## ARCHITECHNICS, INC. 510 MAINE STREET QUINCY, ILLINOIS 62301

PROJECT NO.: 6039

## ADDENDUM NO.: 1

Project: Asbestos Abatement at <u>NORTHEAST MISSOURI ELECTRIC POWER COOPERATIVE</u> <u>3705 N BUSINESS HIGHWAY 61</u> <u>PALMYRA, MO 63461</u>

**D1.0**

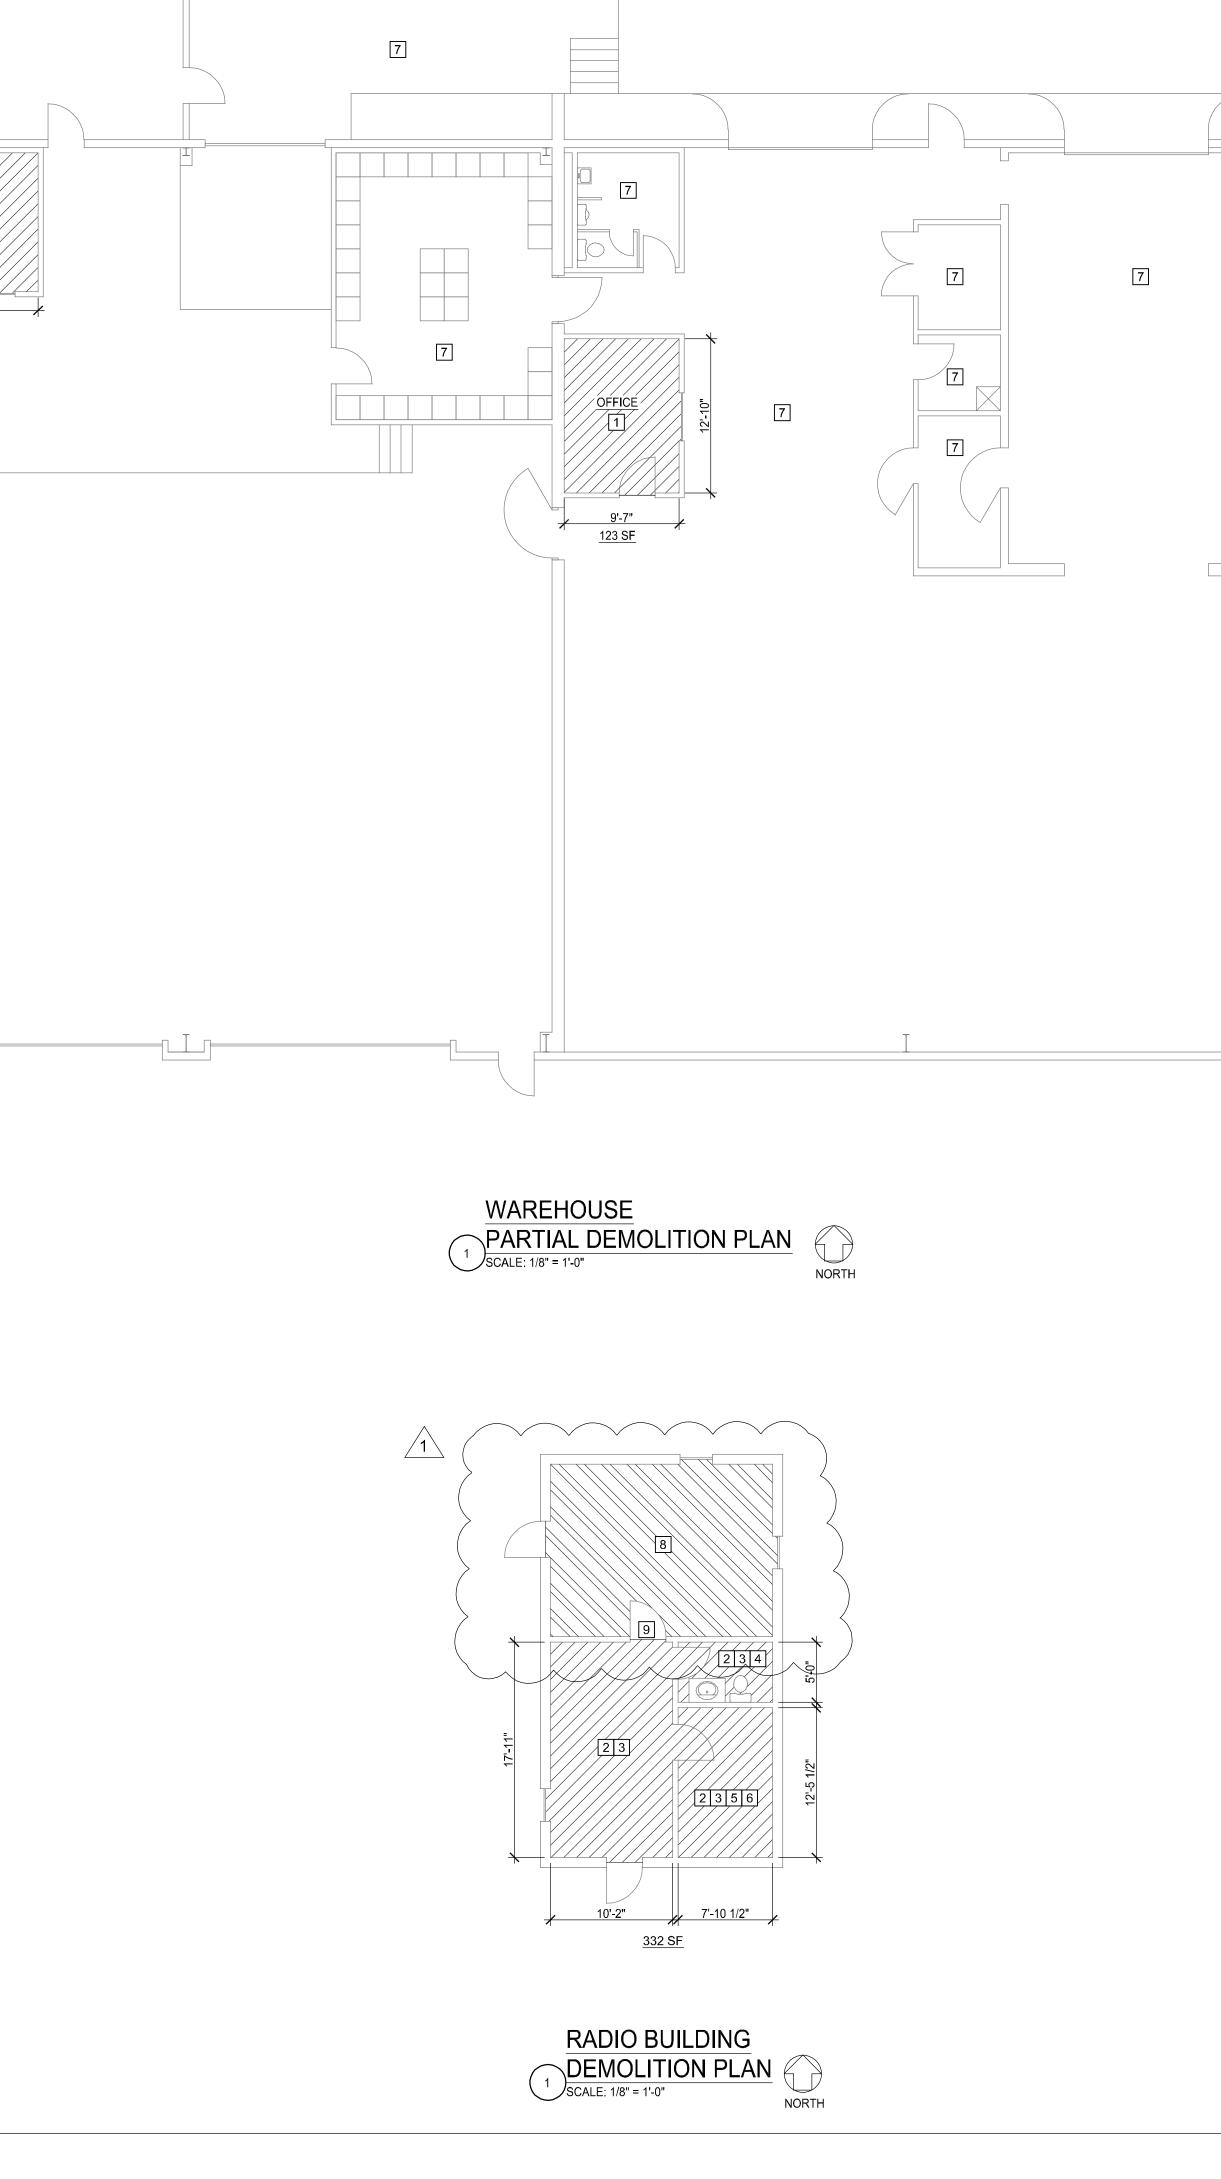
1.0 D1.0

Replace with attached revised drawing.

- 1. COMPLETELY REMOVE EXISTING VCT FLOORING, RUBBER WALL BASE, AND ALL ADHESIVE. REMOVE THRESHOLDS AS REQ'D TO ACCESS EXISTING FLOORING
- 2. COMPLETELY REMOVE EXISTING VCT FLOORING, WOOD WALL BASE, AND ALL ADHESIVE. REMOVE THRESHOLDS AS REQ'D TO ACCESS EXISTING FLOORING 3. ELECTRIC STRIP HEAT TO BE REMOVED BY OWNER PRIOR TO
- DEMOLITION 4. OWNER SHALL REMOVE AND REPLACE /1\

/1\

- EXT'G WATER CLOSET 5. ELECTRIC WATER HEATER AND SHELF TO BE REMOVED BY OWNER PRIOR TO DEMOLITION
- 6. SHELVING TO BE REMOVED BY OWNER PRIOR TO DEMOLITION
- 7. NO WORK IN THIS ROOM 8. ALTERNATE BID 01 - ADDITIONAL ABATEMENT IN EQUIPMENT ROOM. OWNER SHALL COORDINATE WITH MOVING EQUIPMENT AS NECESSARY. 9. IF ALTERNATE BID 01 IS NOT ACCEPTED, CUT TILE DIRECTLY UNDER DOOR
